UNITED STATES
NUCLEAR REGULATORY COMMISSION

SUBJECT: ISSUANCE OF AMENDMENTS - CATAWBA NUCLEAR STATION, UNITS 1 AND 2
FUEL POOL ENRICHMENT AND BORON CONCENTRATION LIMITS
(TAC NOS. M90447 AND M90448)

SAFETY EVALUATION BY THE OFFICE OF NUCLEAR REACTOR REGULATION
RELATED TO AMENDMENT NO. 134 TO FACILITY OPERATING LICENSE NPF-35
AND AMENDMENT NO. 128 TO FACILITY OPERATING LICENSE NPF-52
DUKE POWER COMPANY, ET AL.
CATAWBA NUCLEAR STATION, UNITS 1 AND 2
DOCKET NOS. 50-413 AND 50-414

Table 3.9-1

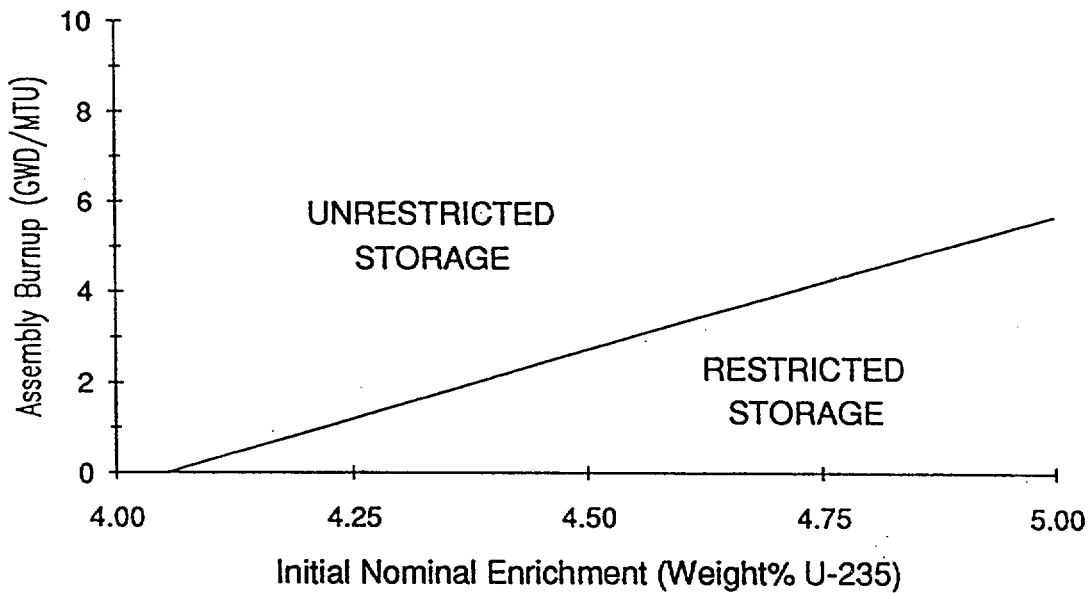
Tables 3.9-1 and 3.9-2 contain a footnote which would allow for specific criticality analyses for fuel which differs from those designs used to determine the requirements for storage defined in these tables. This would allow storage of fuel from the licensee's other facilities, pursuant to provision 2.B(7) of the Catawba Facility Operating Licenses, or storage of individual fuel rods as a result of fuel assembly reconstitution. These analyses would require using the NRC approved methodology described above to ensure that k_{eff} does not exceed 0.95 at a 95/95 probability/confidence level. At the staff's request, the Bases for TS 3.9-13 was revised to include additional discussion which reflects the intended use of this provision.

In response to the NRC staff's concern, the licensee has added a statement to Tables 3.9-1 and 3.9-2 indicating that specific analyses may be performed to qualify fuel assemblies for storage using NRC-approved methodology and has added additional discussion in the Bases to allow for specific criticality analyses for special situations without requiring additional TS changes, as discussed above.

Fuel which differs from those designs used to determine the requirements of Table 3.9-1 may be qualified for Unrestricted storage by means of an analysis using NRC approved methodology to assure that k_{eff} is less than or equal to 0.95.

Figure 3.9-1
Required 3 out of 4 Loading Pattern
for Restricted Storage

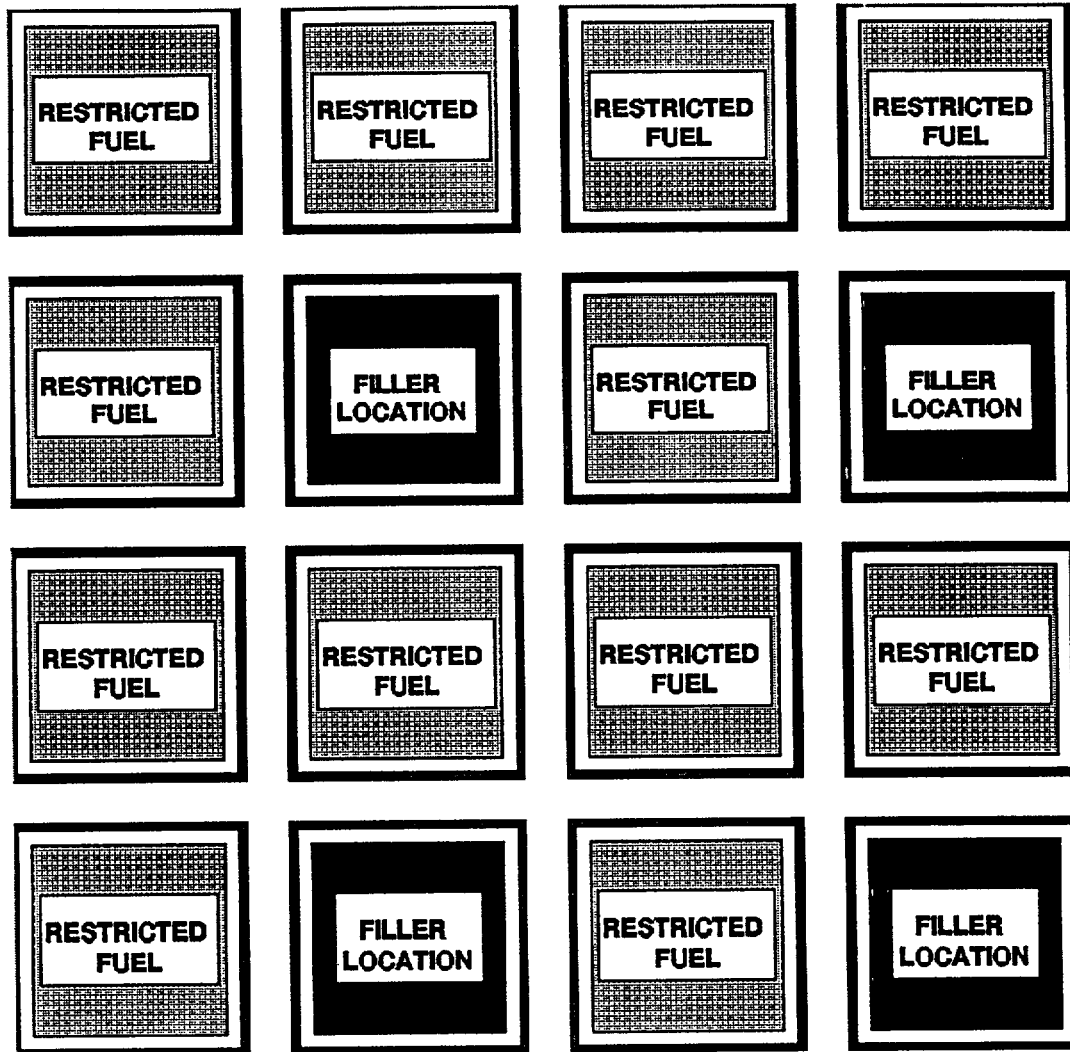
Boundary Condition: Any row bounded by an Unrestricted Storage Area shall contain a combination of restricted fuel assemblies and filler locations arranged such that no restricted fuel assemblies are adjacent to each other.
Example: In the figure above, row 1 or column 1 can not be adjacent to an Unrestricted Storage Area, but row 4 or column 4 can be.

(2) TS 3/4.9.13 is being added to specify the new fuel storage requirements given in Tables 3.9-1 and 3.9-2 and Figure 3.9-1 based on the reactivity analyses evaluated and approved above.
